1201 F / 1201 FP

The new model 1201 F offers important improvements in comparison to the previous model (1200 F).

Fig. 1

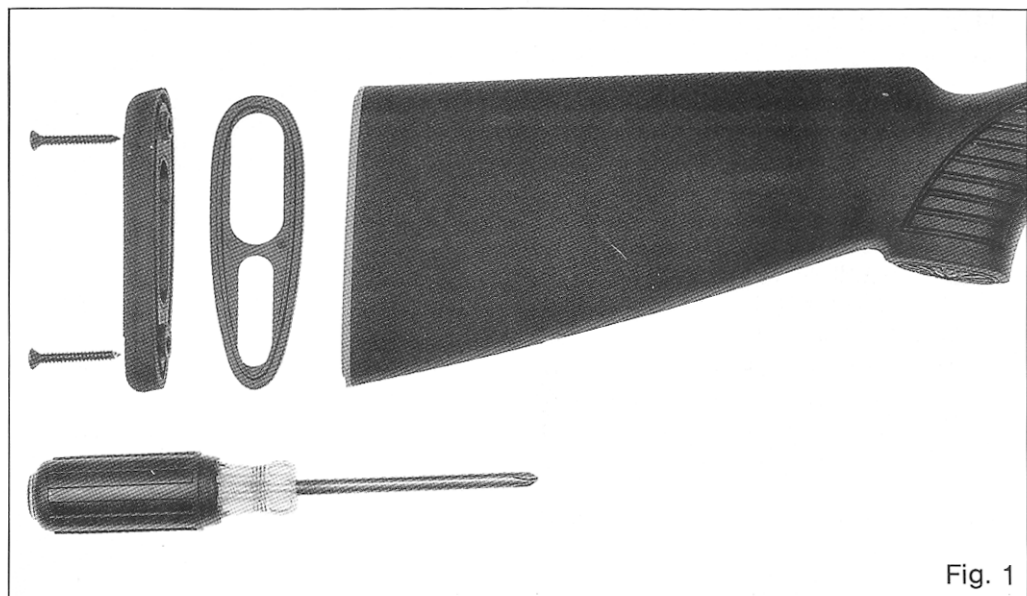
In order to modify the drop it is necessary to use the appropriate modification set consisting of a metal plate and a plastic spacer.

- 60 mm. set (factory set)
- 55 mm. set on request
- 50 mm. set on request

It is advised to have the operation carried out by a competent gunsmith (use a 13 mm. hexagonal tube spanner, after removing rubber recoil pad with a medium sized cross-point screwdriver).
